RSB 584
Sep 30, 2022

NHTSA #22V 583
TC #2022-436

RECALL SERVICE BULLETIN

Description: Incorrect Fuel Line

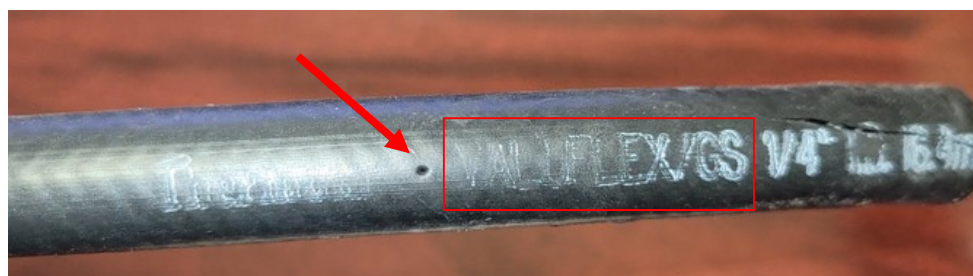
It was recently discovered that a general purpose hose was inadvertently used in place of the 1/4" fuel line in ITR's powered heaters. It is unclear in which models this general purpose line was installed, but it would be within the range of the date codes in the above serial numbers.

The above fuel line is the correct type. It has "FUEL LINE SAE30R7" marked on it. The incorrect hose can be identified by either marking of "VALUFLEX/GS" or by what appear to be holes in the hose as shown below.

This hose is subject to leaking. If a heater is discovered to have this hose, it must be changed out with the appropriate fuel line as per the instructions below.

The replacement hose kit is part number 21015

Step 1:

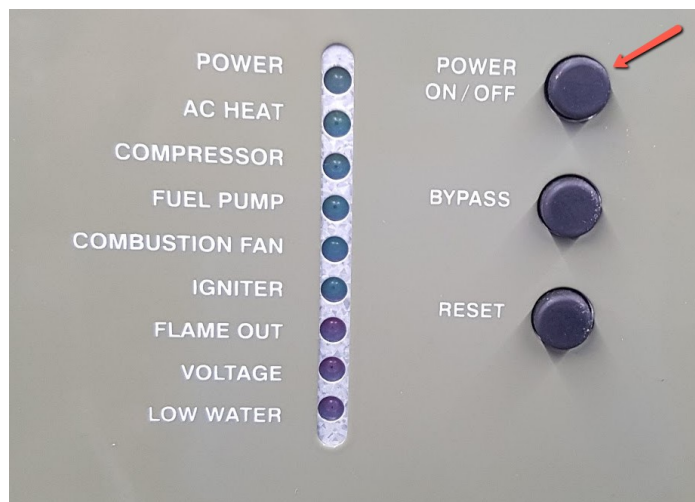
Press the power button and make sure the Power LED has turned off. Wait until the combustion fan turns off. This will take 2-4 minutes.

Remove these screws to gain access to the inside of the heater.

Step 3:

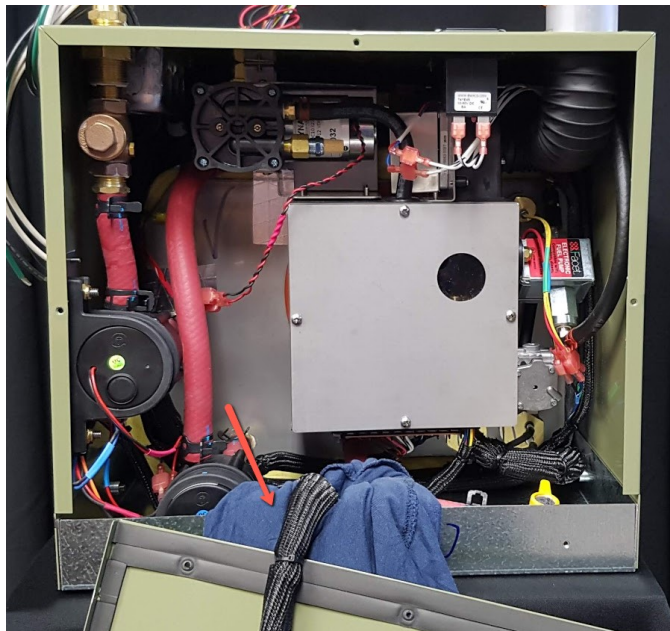
1. Place a rag underneath the wires to protect them from getting damaged on the edge of the bottom tray, and fold down the front cover.
2. Place a spacer underneath the front cover to ensure the buttons don't get pushed accidentally during service.

Remove the three screws from the combustion fan intake and pull it down and out to provide better access to the fuel line.
